RE: NBHS - BG 24-192 - Change Order 25 - Tennis Court Lighting

Change Order

Phase II Athletics - Bid Package No. 2 -
NB Field House
Bullitt County Public Schools

REQUEST FOR PROPOSAL

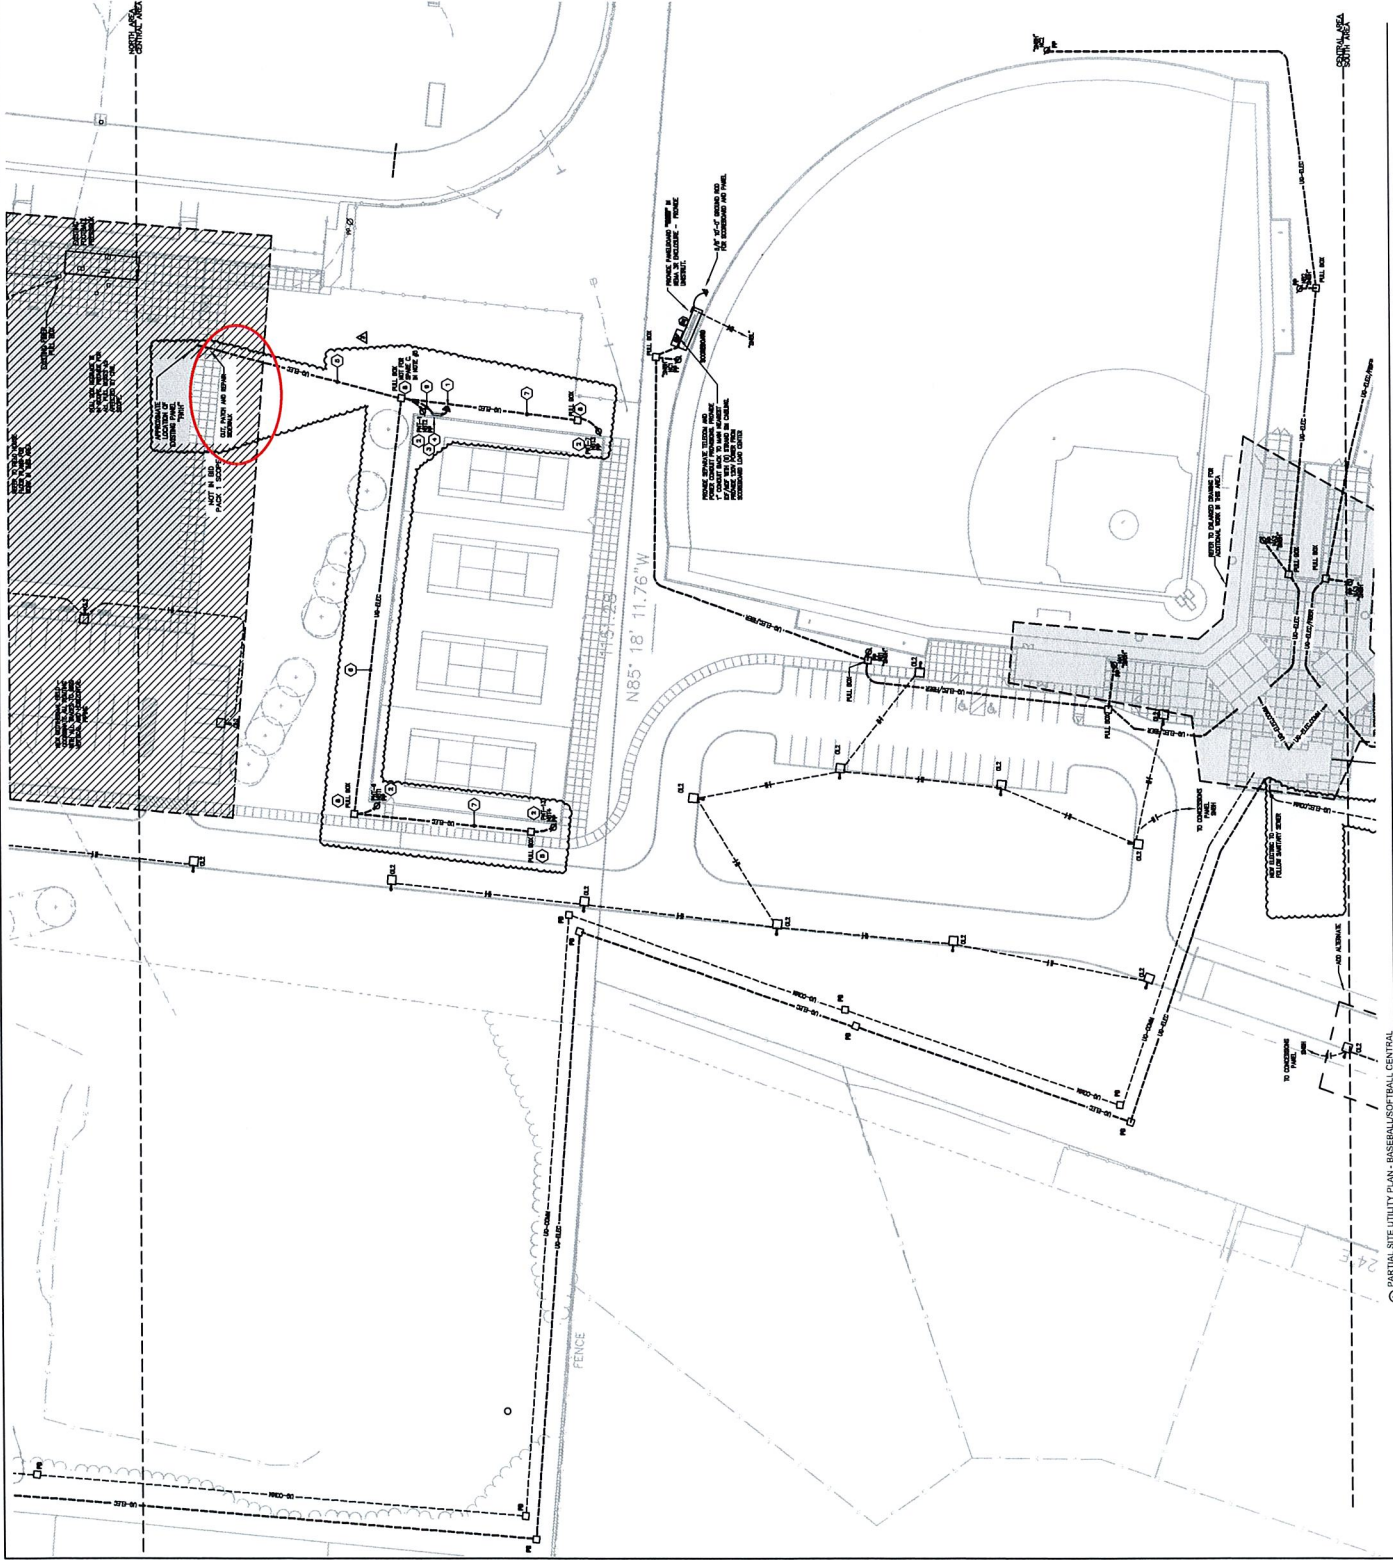
Provide price proposal for the following: Tennis court lighting changes for North, Central and East High Schools

| Item No.1 | Refer to ES0.2

•Sheet added for Tennis Electrical Enclosure details. |

| Item No.2 | Refer to ES1.2_BCHS

•Refer to clouded area for O.F.C.I Musco tennis court sports lighting and associated electrical service. |

| Item No.3 | Refer to ES2.3_BEHS

•Refer to clouded area for O.F.C.I Musco tennis court sports lighting and associated electrical. |

| Item No.4 | Refer to ES3.3_NBHS

•Refer to clouded area for O.F.C.I Musco tennis court sports lighting and associated electrical. |

| Item No.5 | Refer to E5.4

•Refer to clouded area portion of electrical riser for additions. |

| Item No.6 | Refer to E5.8

•Sheet added for electrical schedules. |

| Item No.7 | Refer to E7.0

•Refer to clouded area portion of electrical riser for additions. |
